DOCKET ITEM # 13

ROUTE 1 TRANSITWAY

Issue: Approval of the design for the Route 1 Transitway consistent with the 2008 Transportation Master Plan and the Corridor A Transitway alignment amendment to the 1992 Transportation Master Plan	Planning Commission Hearing:	May 1, 2012
	City Council Hearing:	May 12, 2012
Staff: Susan Gygi, Department of Transportation & Environmental Planning (susan.gygi@alexandriava.gov) Jeffrey Farner, Department of Planning & Zoning (jeffrey.farner@alexandriava.gov)

PLANNING COMMISSION ACTION, MAY 1, 2012: On a motion by Mr. Wagner, seconded by Ms. Fossum, the Planning Commission recommended approval of the Route 1 transitway design subject the staff recommendations and the following revisions as generally depicted in Figure 4:

Figure 4: Perspective of Pedestrian Crossing of Route 1

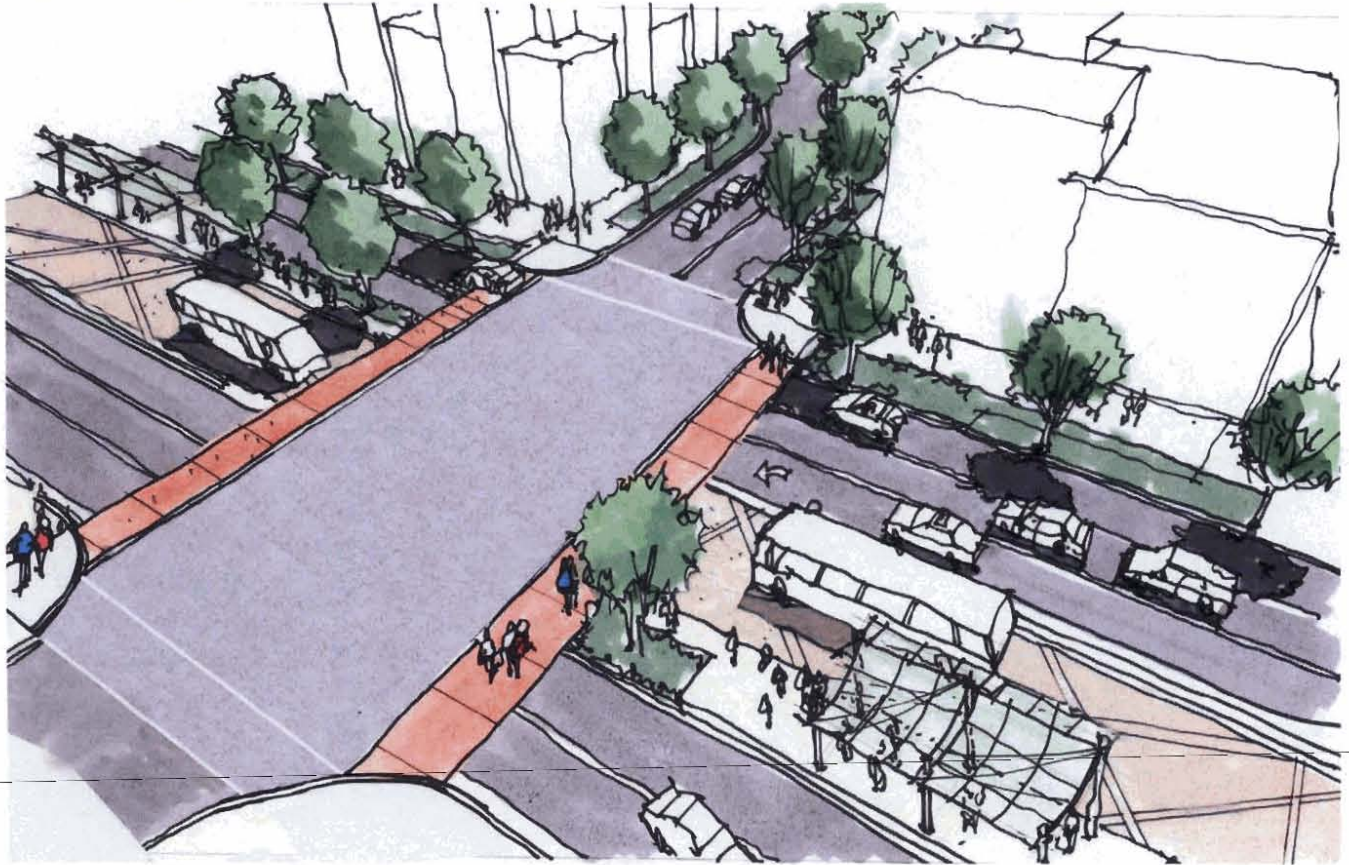
1. Colored and textured concrete at each transit stop;
2. Colored and textured concrete for each pedestrian crosswalk on Route 1; and
3. The final design of the transit stations (shelters) will be subject to future review by the Planning Commission.

4. The transit station areas and pedestrian crosswalks shall be designed to include the following as generally depicted in Figure 4:
 - a. Colored and textured concrete at each transit stop;

- b. Colored and textured concrete for each pedestrian crosswalk on Route 1; and
5. The final design of the transit stations (shelters) will be subject to future review by the Planning Commission.

Map 1: Showing planned northbound traffic access to neighborhood (red circles)

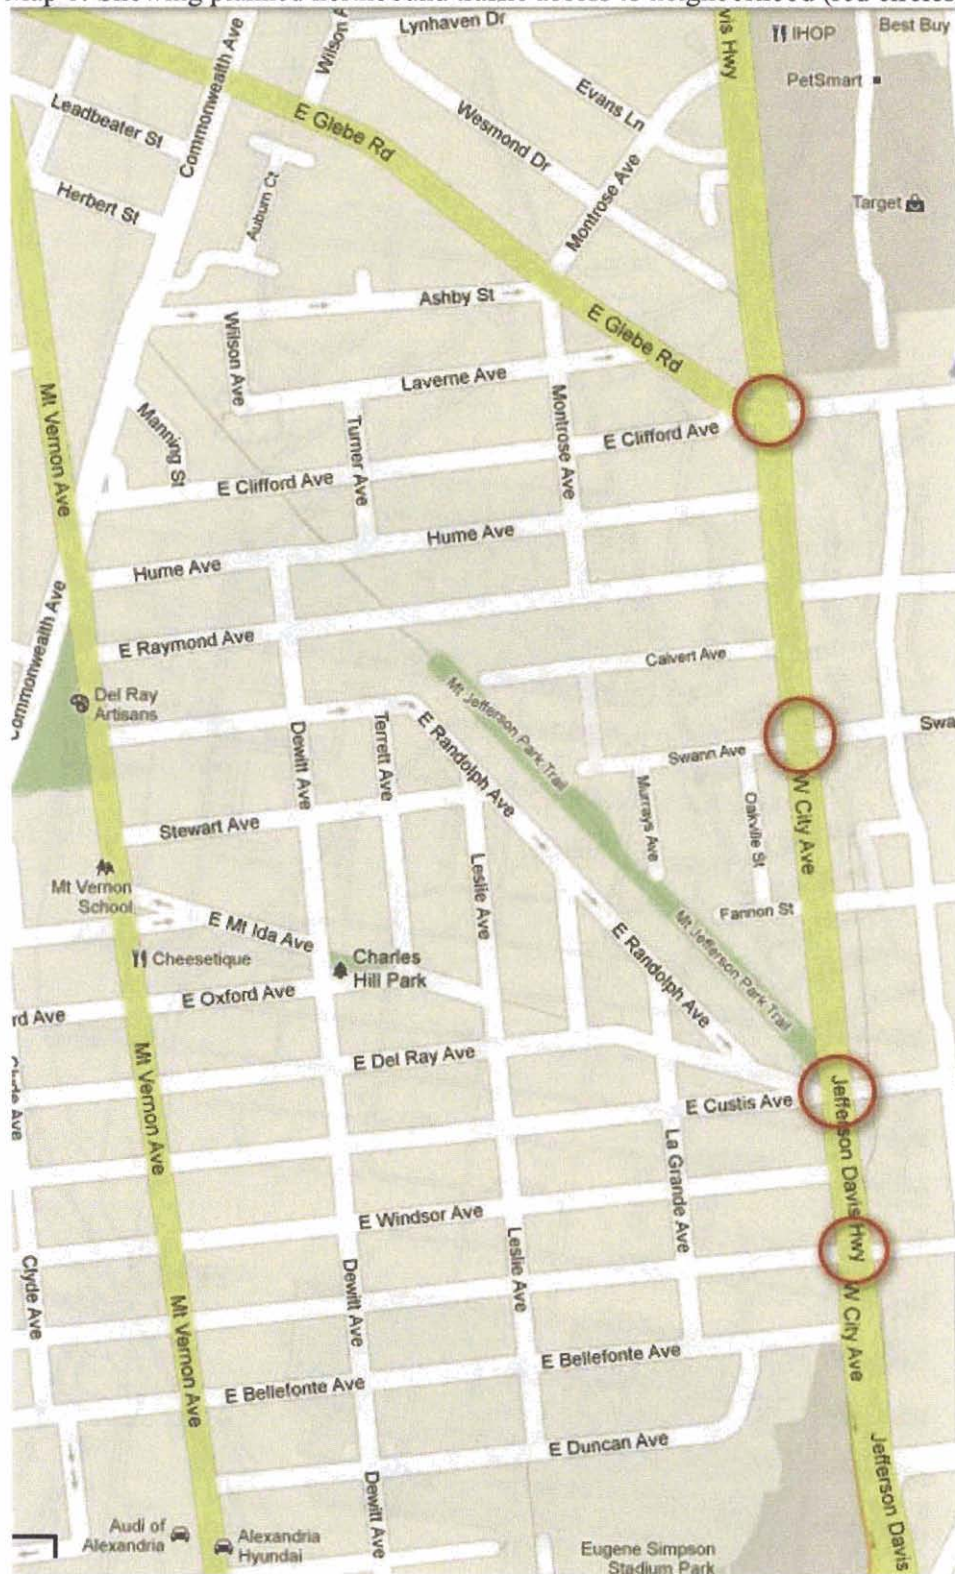
Question #4: What is the envisioned method for north bound Route 1 traffic to access the businesses and neighborhood on the west side?

Question #9: Is the length of the left-turn lane from Route 1 onto East Glebe Road sufficient to handle the number of cars or does the transitway have to come at the complete inconvenience to the residents?

Question #11: What is the reason for not creating a parking district adjacent to Route 1 as part of this process?

Map 1: Showing planned northbound traffic access to neighborhood (red circles)

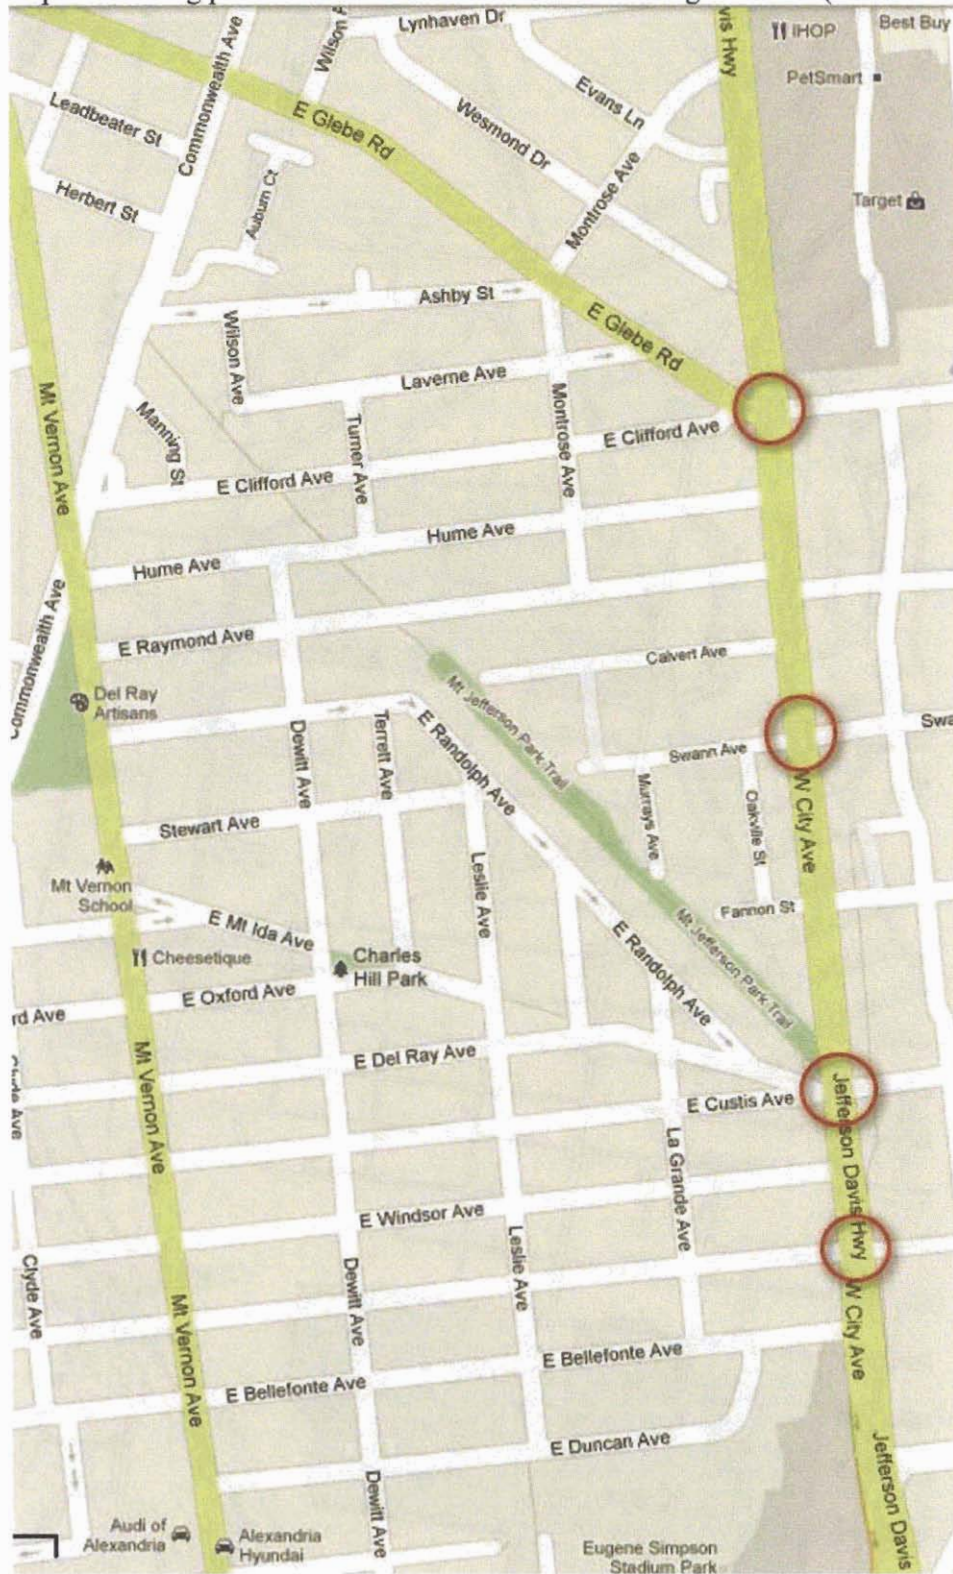
Question #4: What is the envisioned method for north bound Route 1 traffic to access the businesses and neighborhood on the west side?

Question #9: Is the length of the left-turn lane from Route 1 onto East Glebe Road sufficient to handle the number of cars or does the transitway have to come at the complete inconvenience to the residents?

Question #11: What is the reason for not creating a parking district adjacent to Route 1 as part of this process?

Map 1: Showing planned northbound traffic access to neighborhood (red circles)

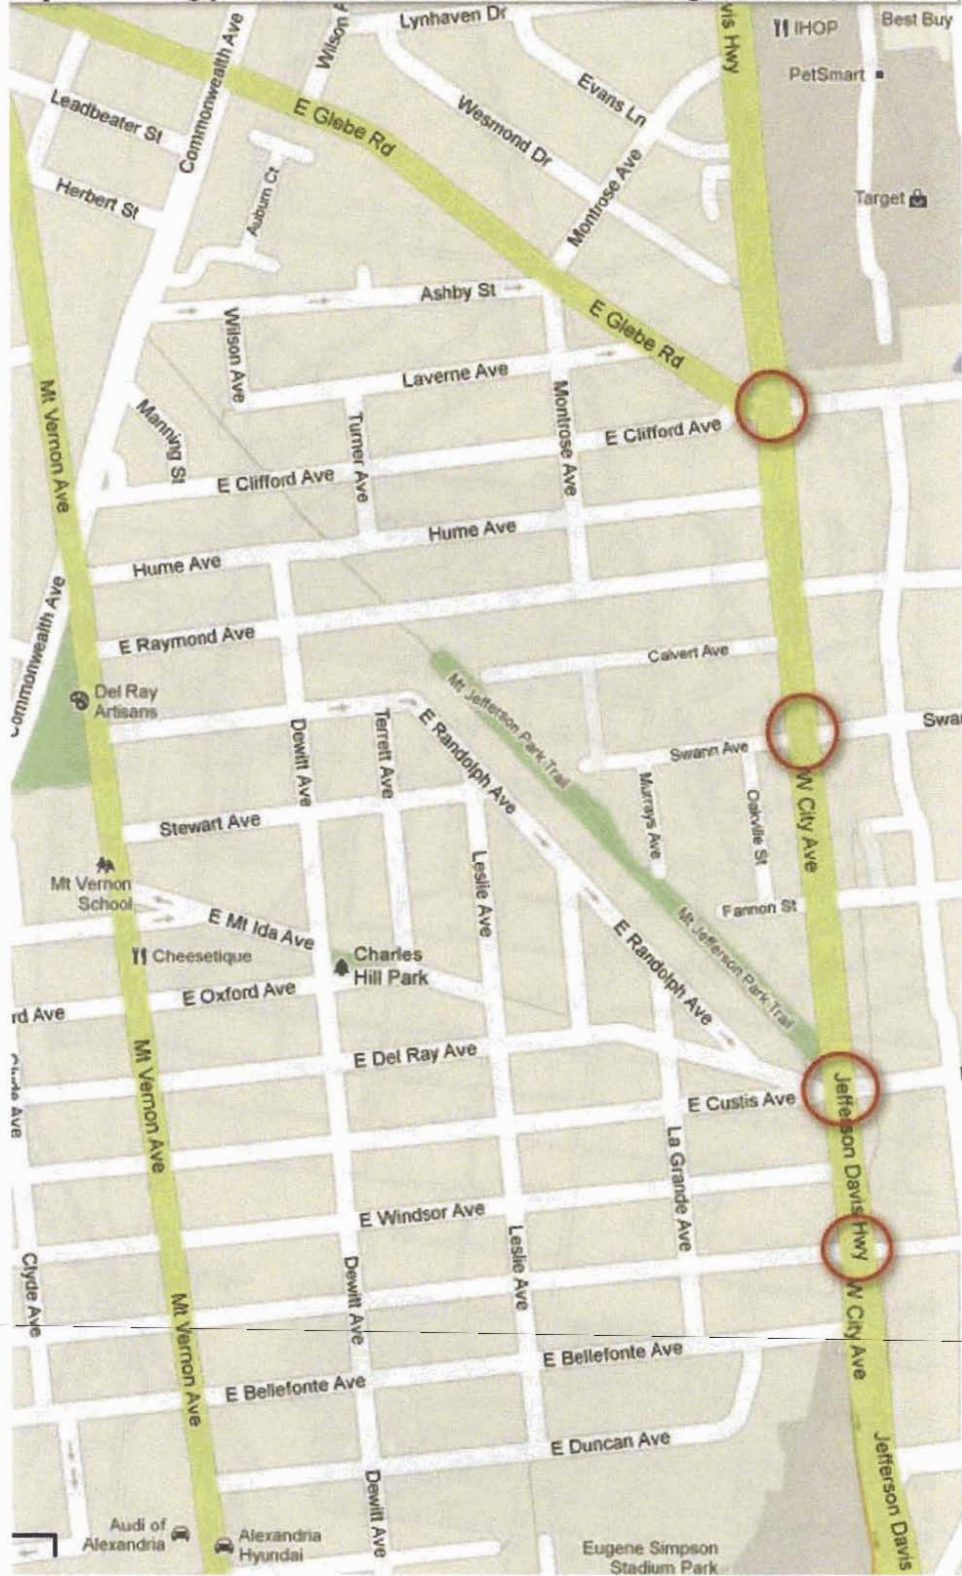
Question #4: What is the envisioned method for north bound Route 1 traffic to access the businesses and neighborhood on the west side?

Question #9: Is the length of the left-turn lane from Route 1 onto East Glebe Road sufficient to handle the number of cars or does the transitway have to come at the complete inconvenience to the residents?

Question #11: What is the reason for not creating a parking district adjacent to Route 1 as part of this process?
